The following changes in the tender documents are effective immediately. This addendum will form part of the contract documents.

Mountain Institution
Building A20 and K
Roof Replacement

**BUILDING A20 (POWERHOUSE)
& BUILDING K (KITCHEN)
ROOF REPLACEMENT**

.5 Reference: **DRAWINGS** Drawing A10 BUILDING K ROOF DETAILS

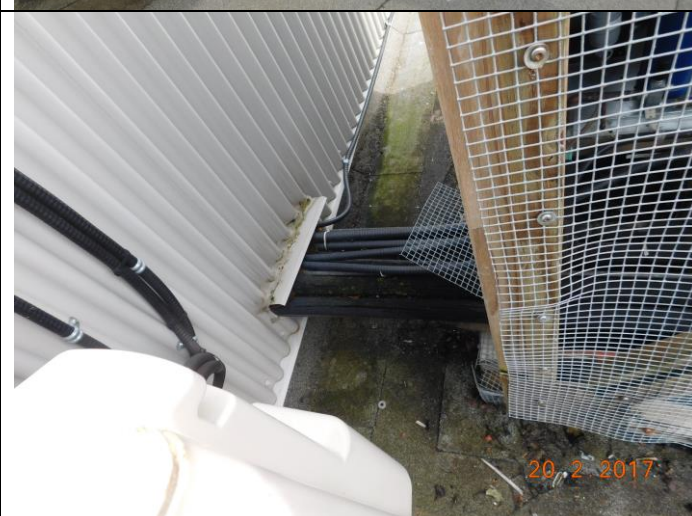
a) **[ADD]** Detail #7: Roof Anchor Flashing Detail. (attached)

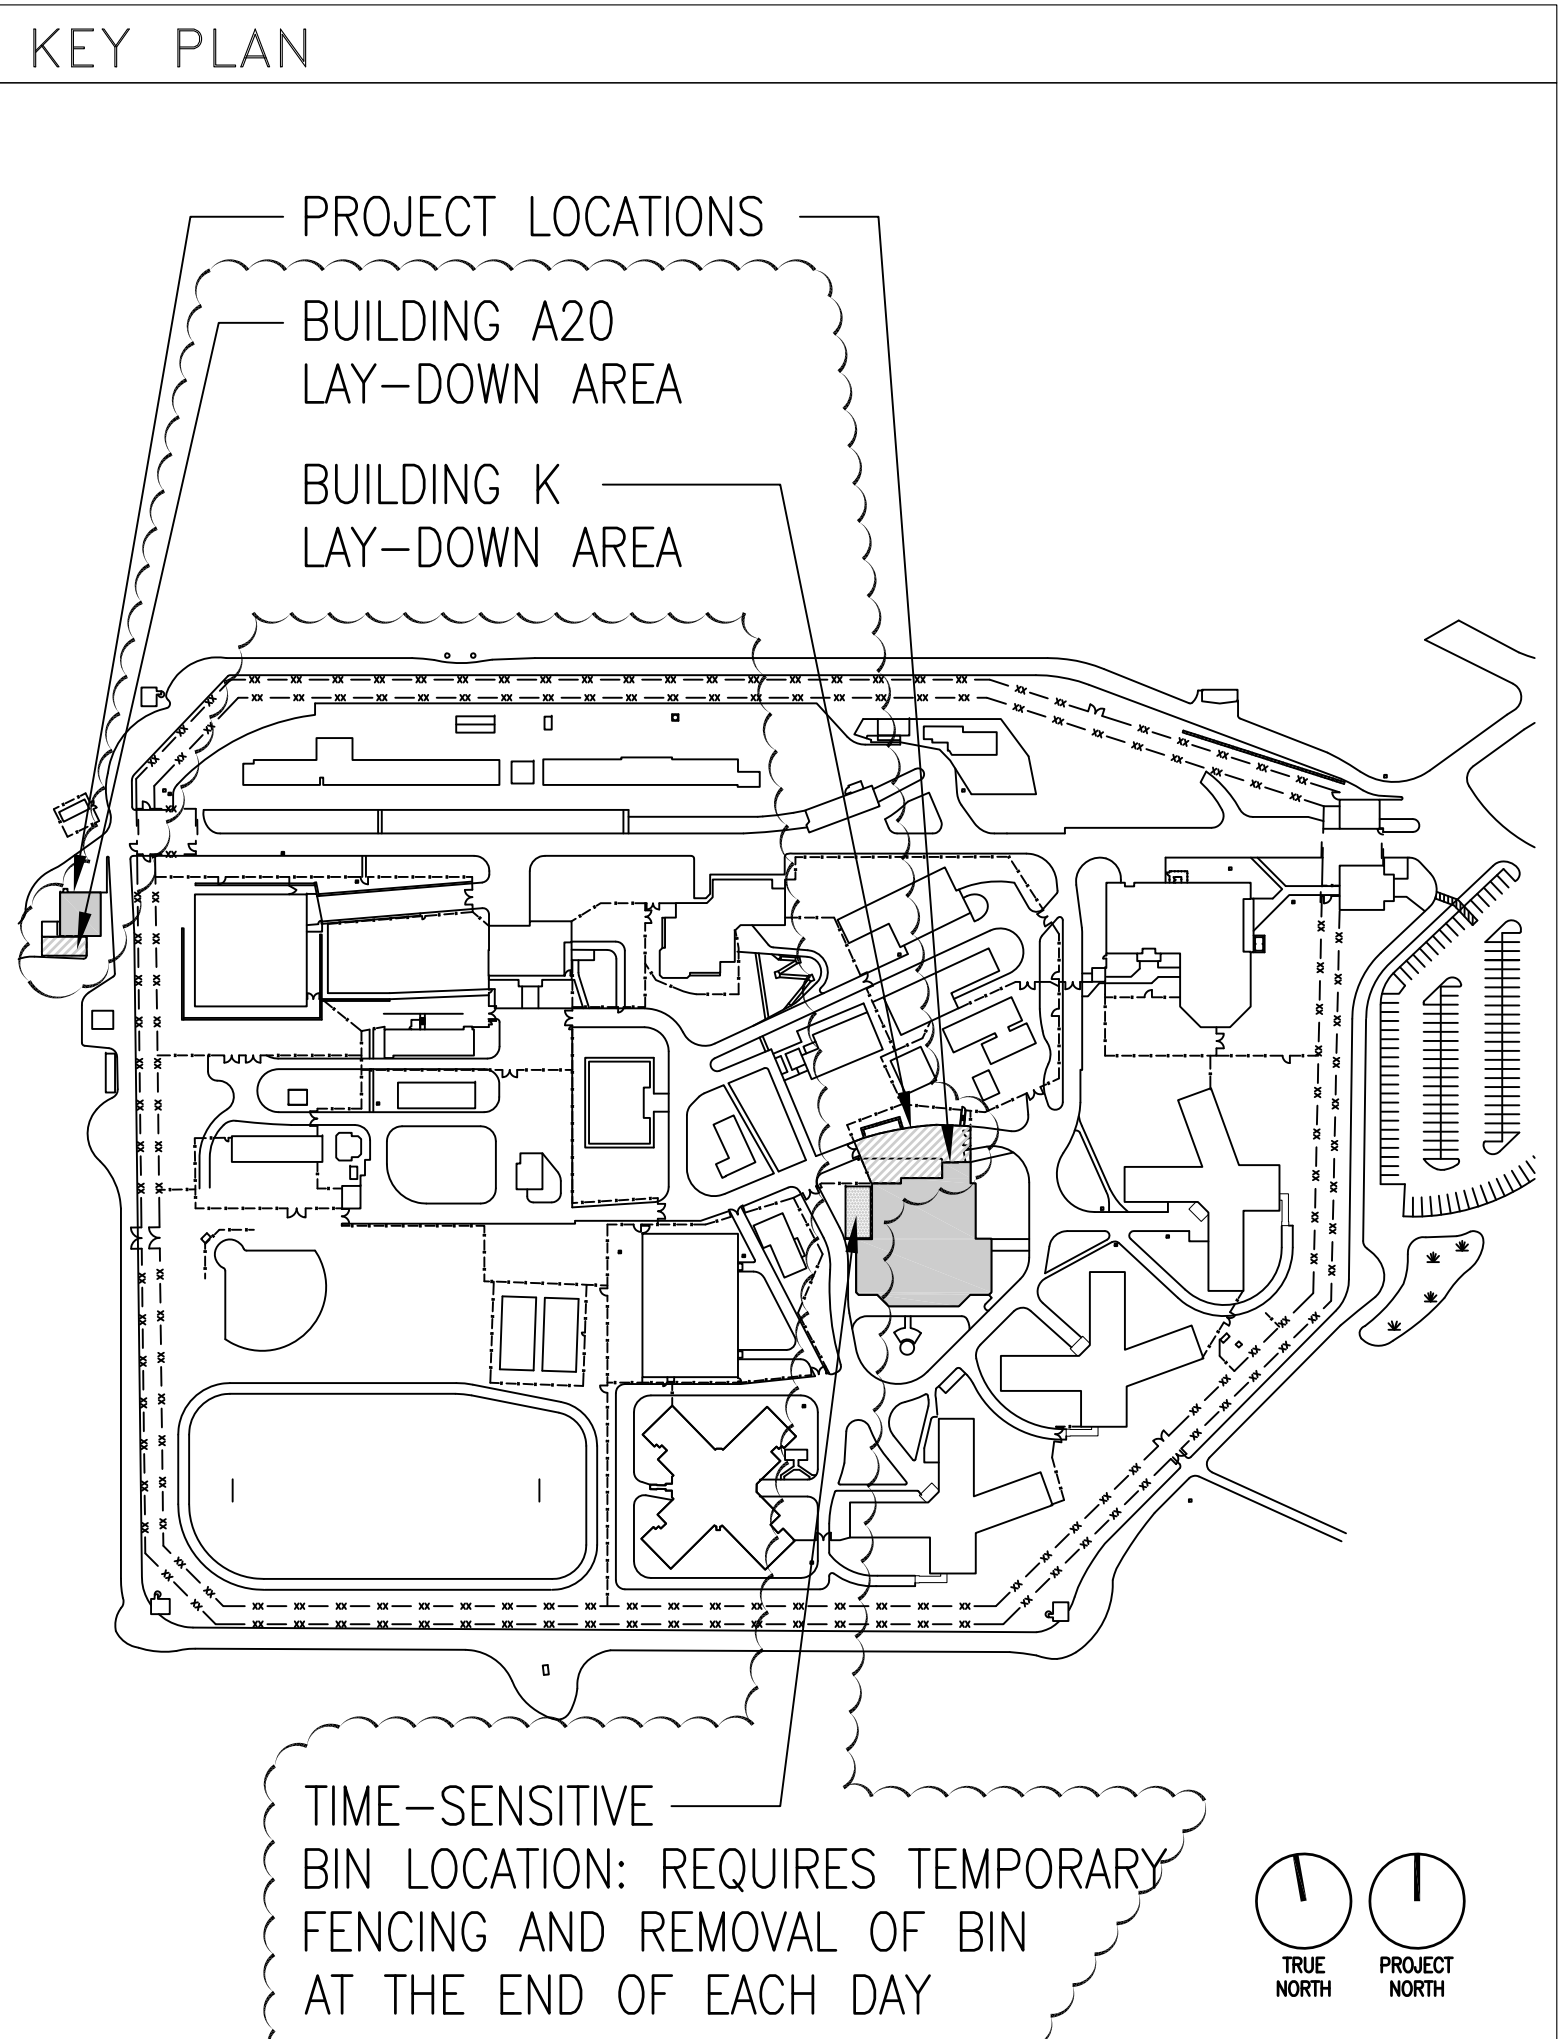
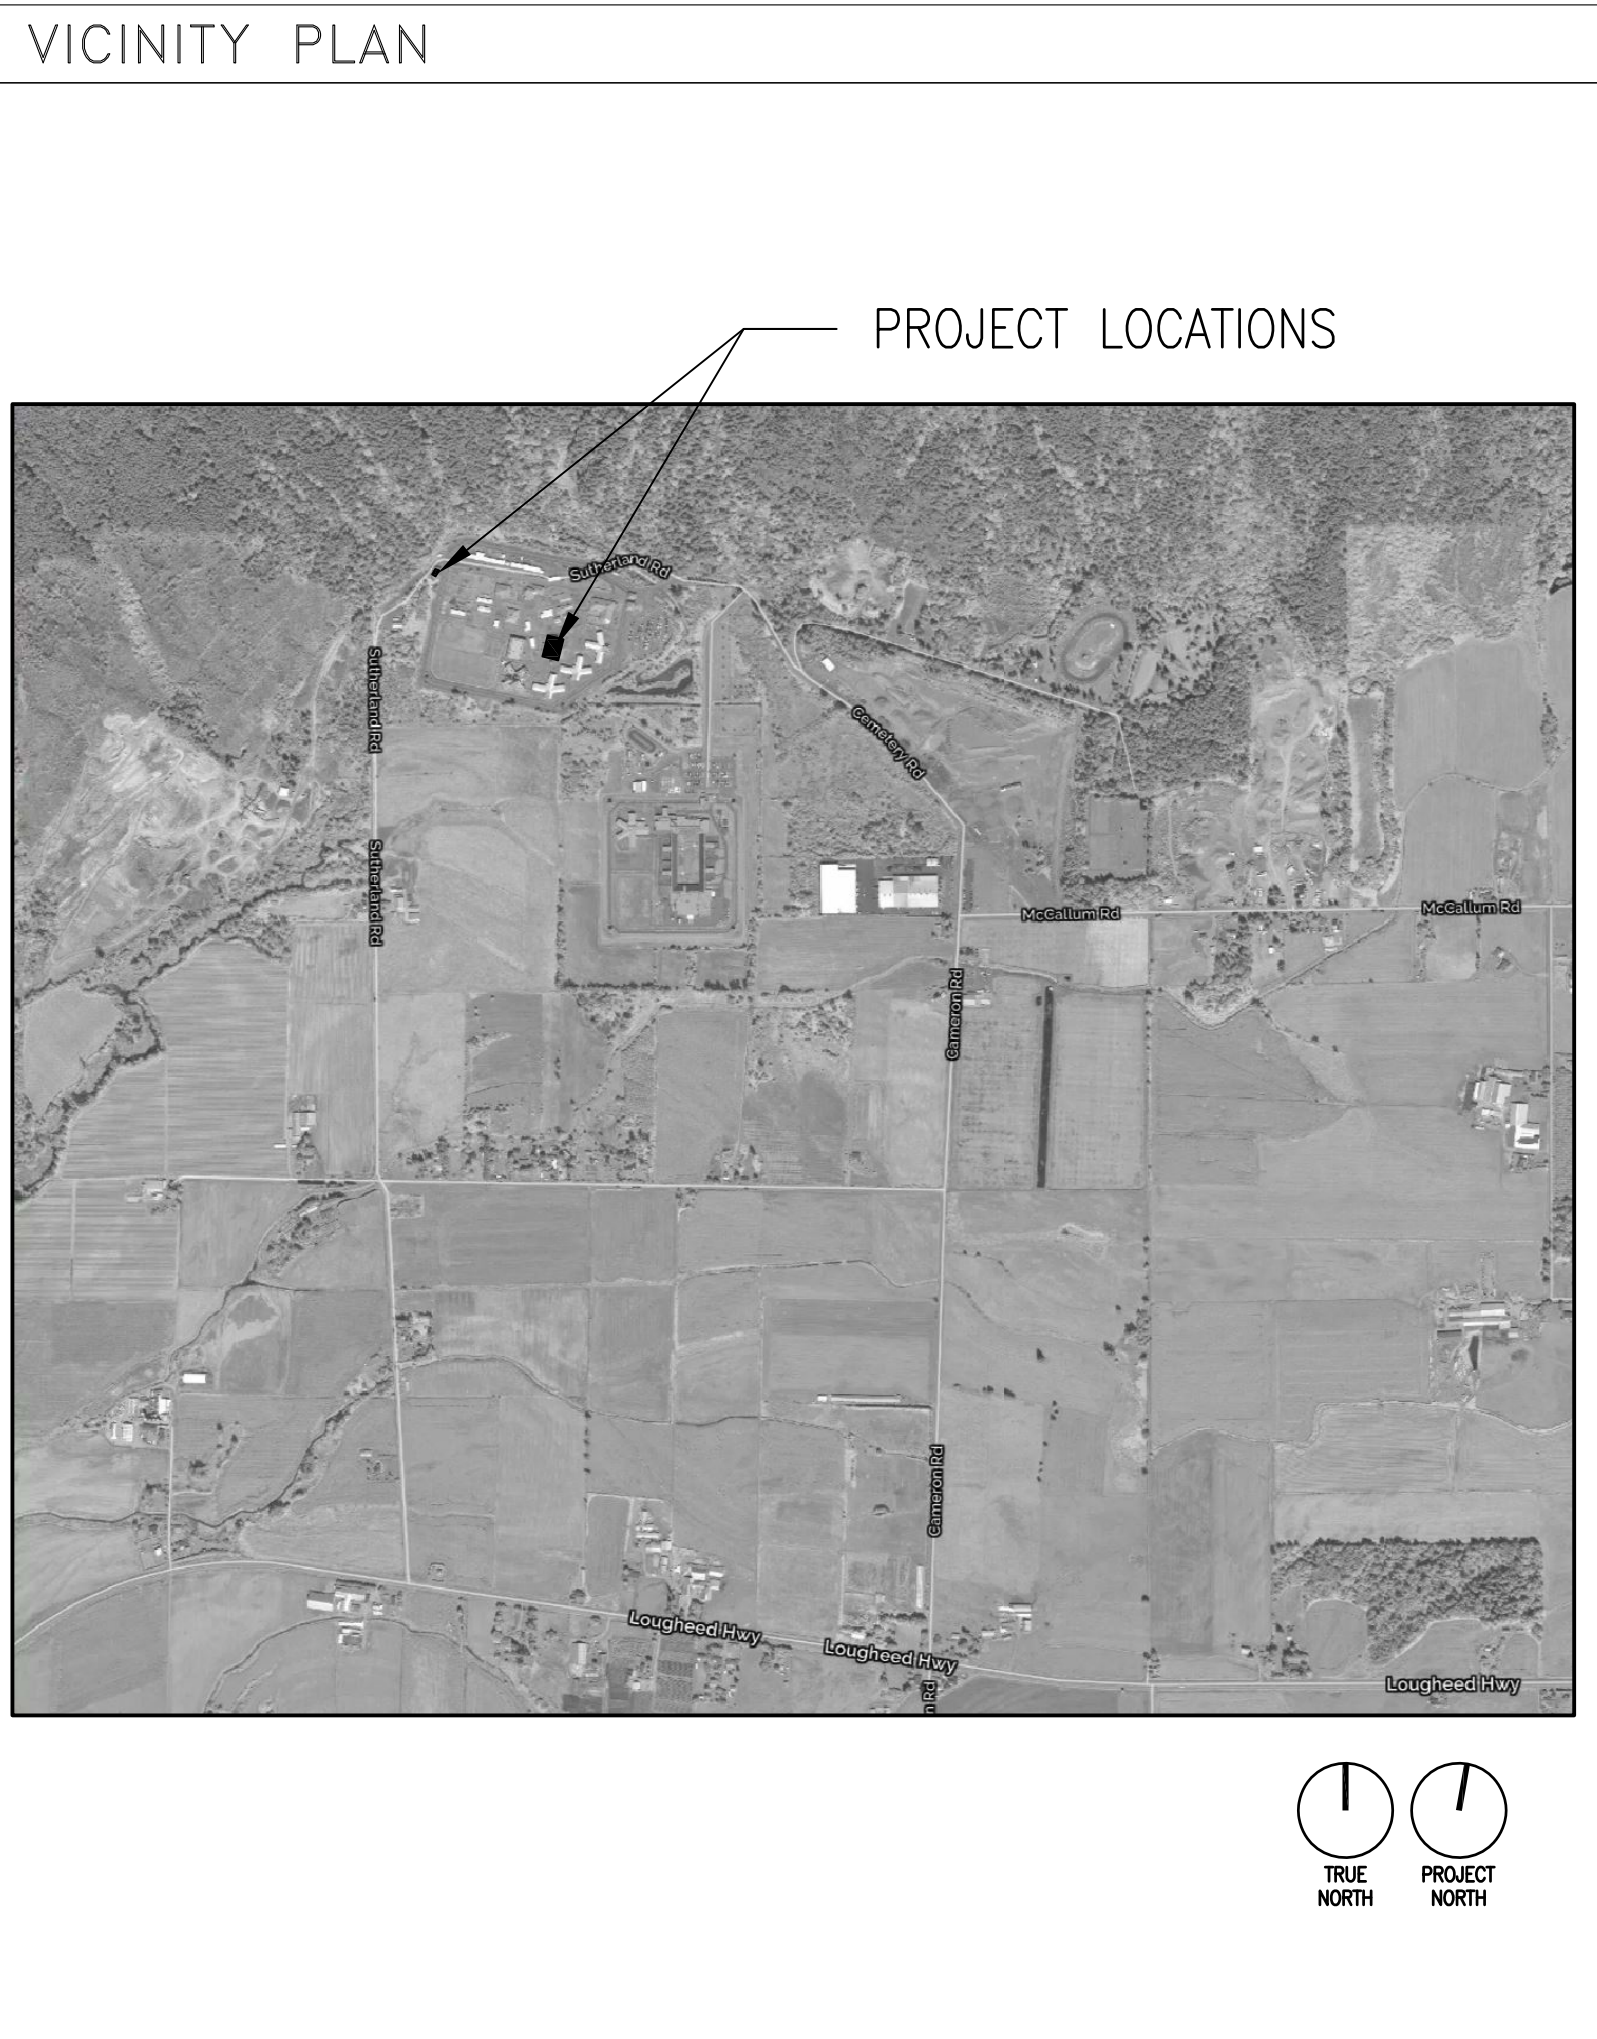
- .1 Reference: **DRAWINGS** Drawing G01 GENERAL NOTES AND DRAWING INDEX
- a) **[ADD]** The following references to KEY PLAN: Lay-down area for building A20; Lay-down area for building K; time-sensitive bin location: requires temporary fencing and removal of bin at the end of each day. (attached)

07 ROOF ANCHOR FLASHING DETAIL
A10 1 : 5

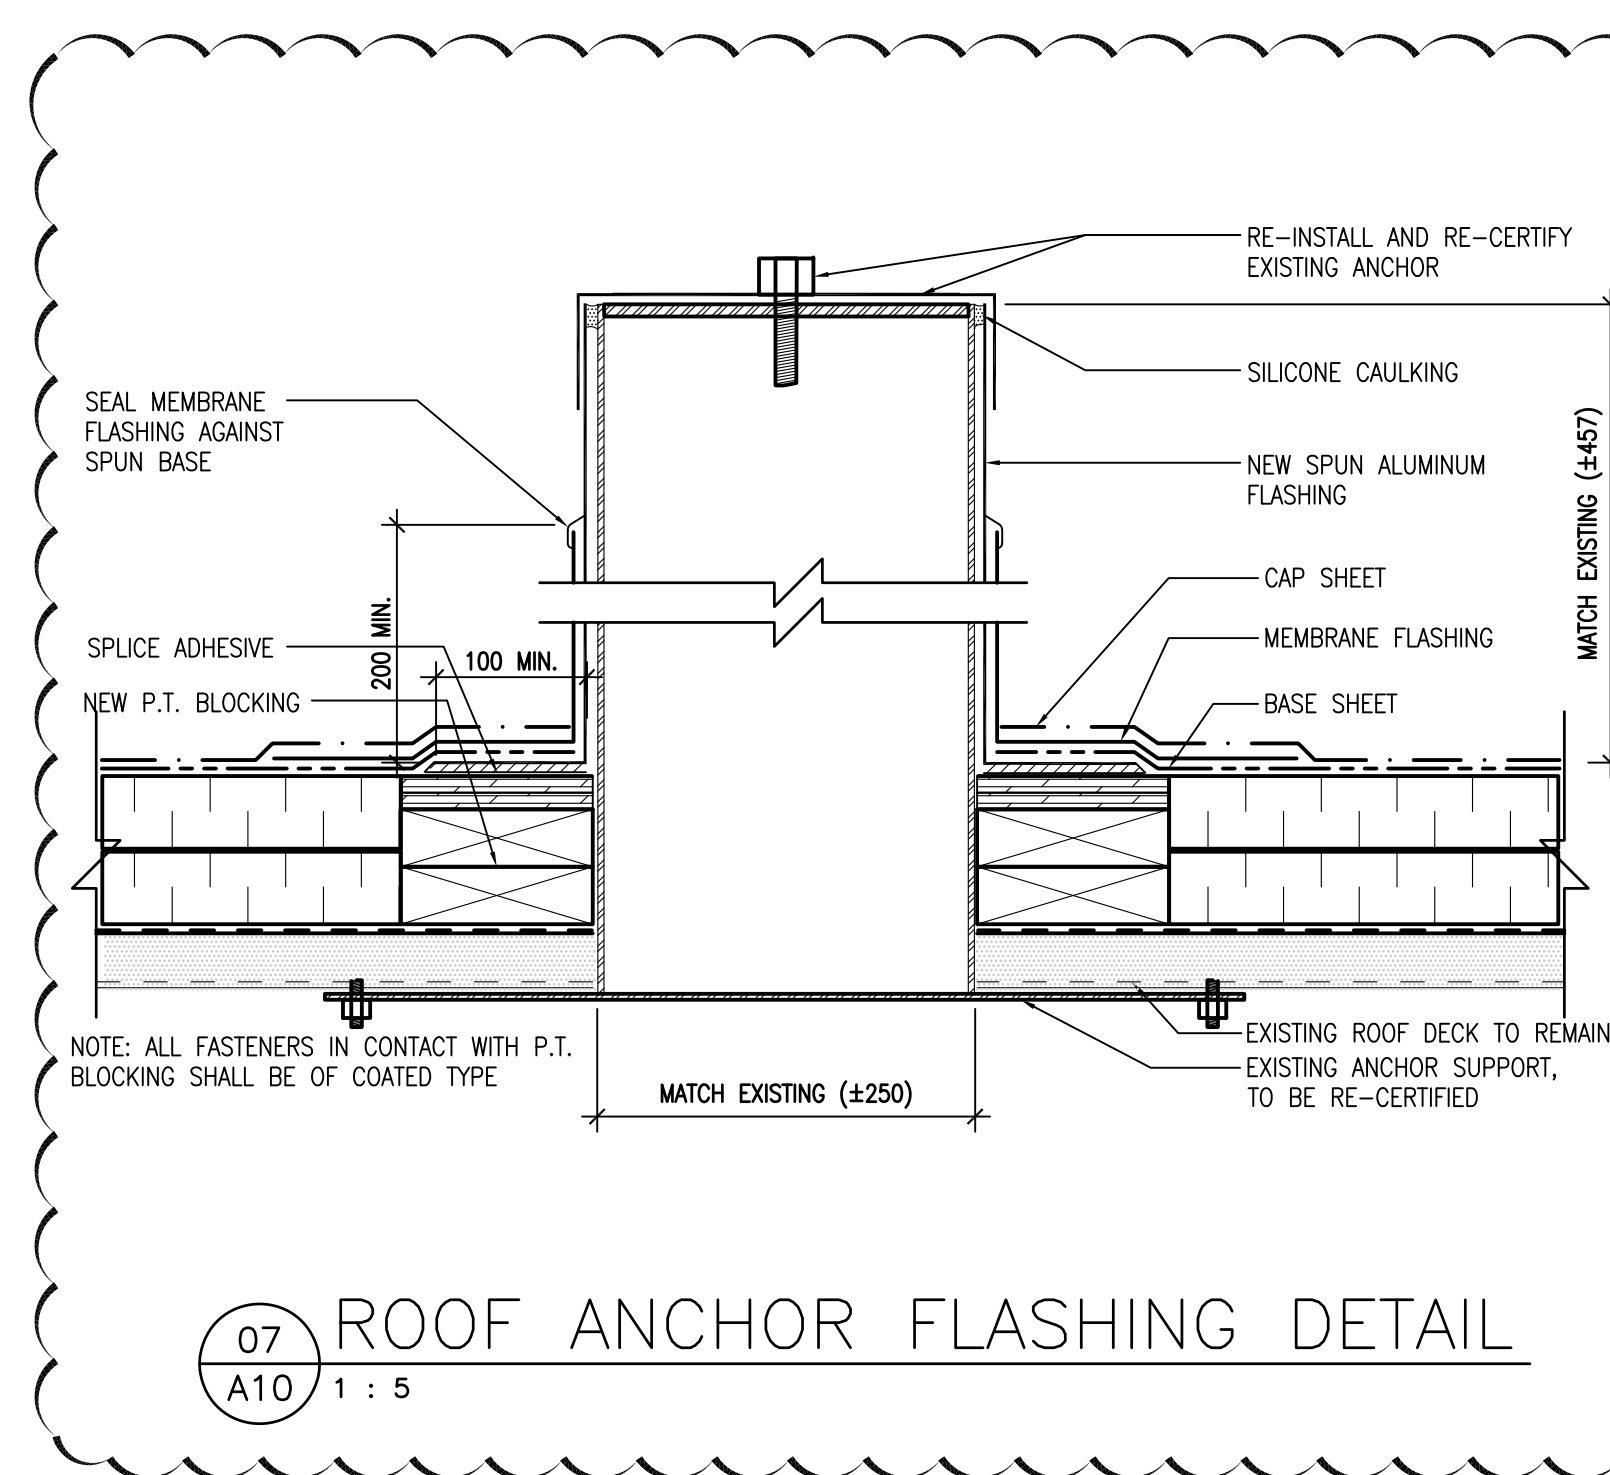
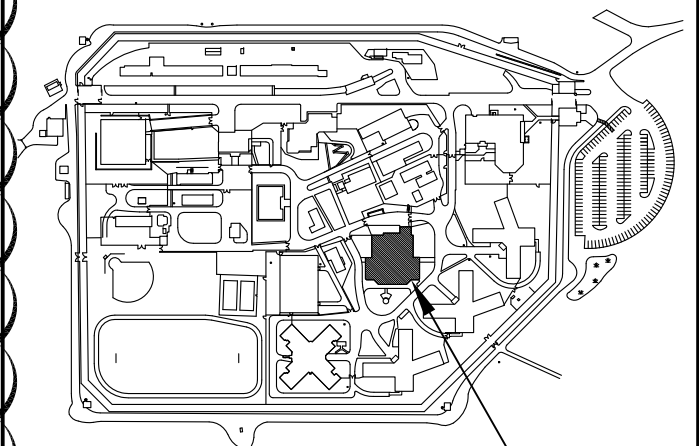
“ROOF CONTRACTOR TO RETAIN A BC REGISTERED P.ENG., WHO SHALL RE-CERTIFY THE EXISTING ROOF ANCHORS AND PROVIDE ASSURANCE SCHEDULES. INSTALL NEW FLASHING FOR EXTERIOR ROOF ANCHOR, SEE DETAIL 07/A10.”
